Land Use Review Appeal to  
**Portland City Council**

Appeal of Historic Landmarks Commission Decision  
of Approval with Conditions

LU 17-153413 HRM AD

# **THE PORTLAND BUILDING**

Ground Floor Windows - North façade – 37% of length

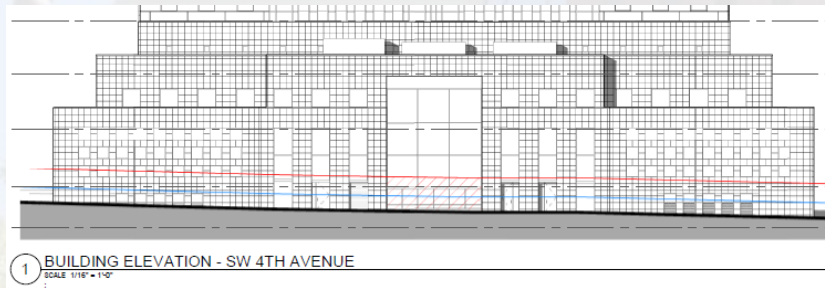
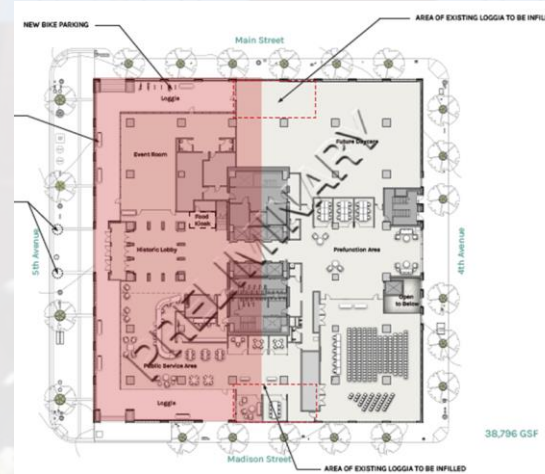
1. 33.130.230.C – to reduce the amount of ground floor windows on the north façade to 37% (from 50%) of the wall length and, on the east façade, to 0% (from 50%) of the wall length and to 0% (from 25%) of the wall area.
2. 33.510.225 – to reduce the depth of the ground floor active uses (at the loggia) from the required 25' depth to approximately 16' to 20'.

*Final Findings (pg. 31) – Because the proposal constitutes a Major Remodel, the Ground Floor Windows standard must be met...this means that new windows would have to be cut into the building to meet this standard...Because increasing the size of the windows to meet this standard on the north and east façades would destroy the essential vision of Graves' design, the commission believes that preservation of the character of the historic resource is more important than meeting the purpose of the standard."*

G. The proposed air handling units shall either be located at the interior of the building, or be significantly (at least 50%) reduced in scale (and not increased in number).

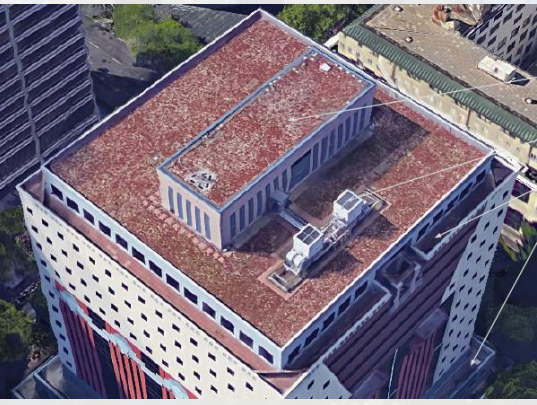
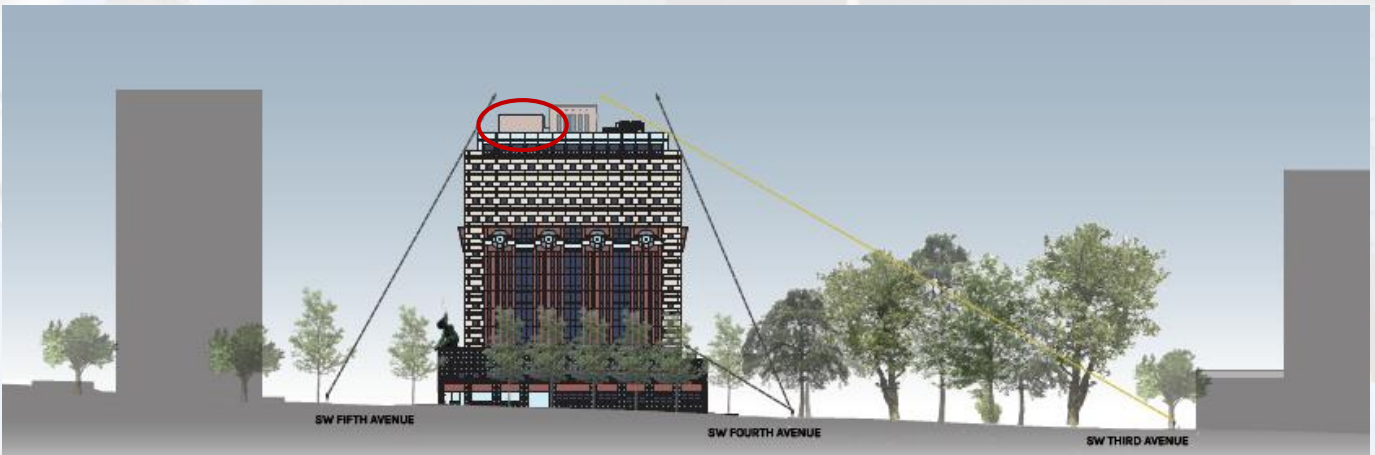
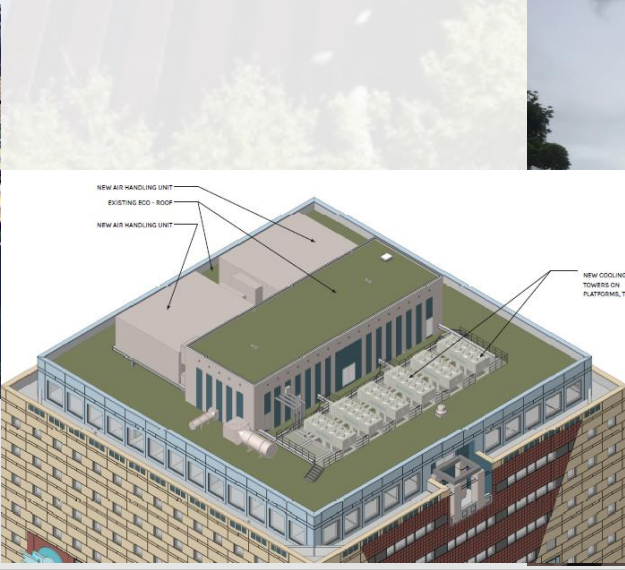
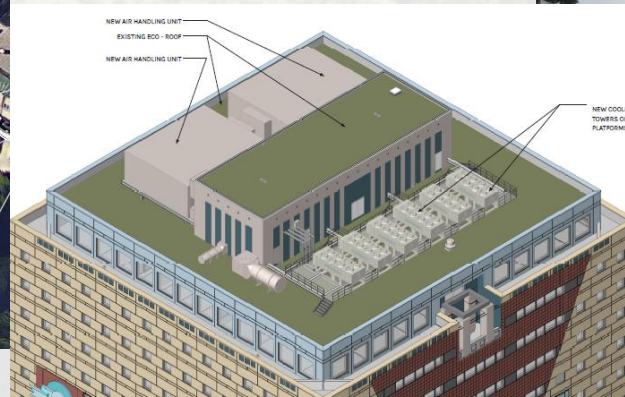
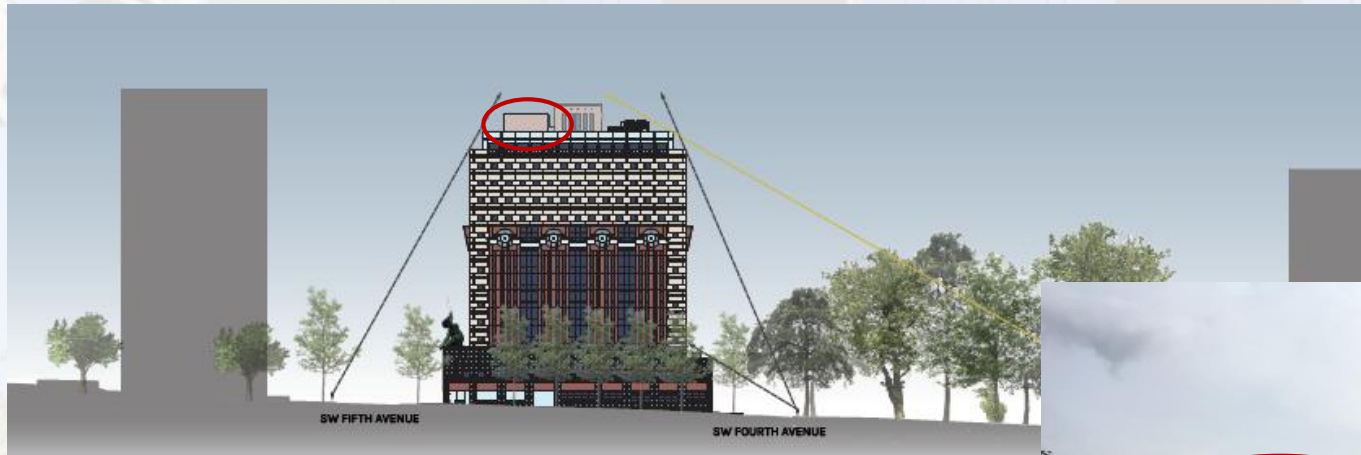
All Approval Criteria met without inclusion of Condition G.

No viable alternative.

**Requests Condition G be stricken from Approval.**

Findings (pg. 28) – *The Historic Landmarks Commission found that CCFDG C11 – Integrate Roofs and Rooftops was not met by the proposal, noting concerns with the size and visibility of the units and lack of integration with the rest of the building; therefore a condition was added that they be reduced and/or relocated.*

Final Findings (pg. 28) – *“At the current scale , the proposed units will be highly visible from the right-of-way only one block away, particularly from the south.” A condition (G) was added to rectify this.*
